Technical change for 1543490000 SAI-WDF 8P M12 M16

Article 1543490000 SAI-WDF 8P M12 M16 will be changed after a transitional period.
Please pass on this Product Change Notification (PCN) to your employees and, if applicable, to your customers.

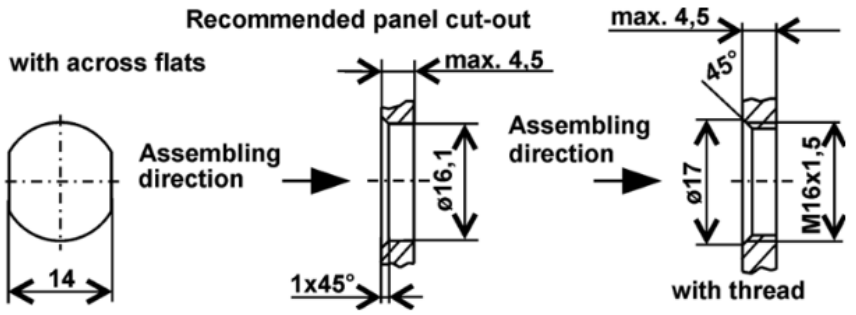
As a part of this product change, the manufacturing process for the housing will change from a turned part to a zinc die-cast part. The dimensions of the wall feed-through will remain the same; only two sides of the thread will be flattened to prevent rotation. In a second step, the contacts used will be replaced with lead-free versions. Once the change has been fully implemented, the product will be RoHS-compliant without exception 6c. All approvals and other technical specifications remain unchanged.
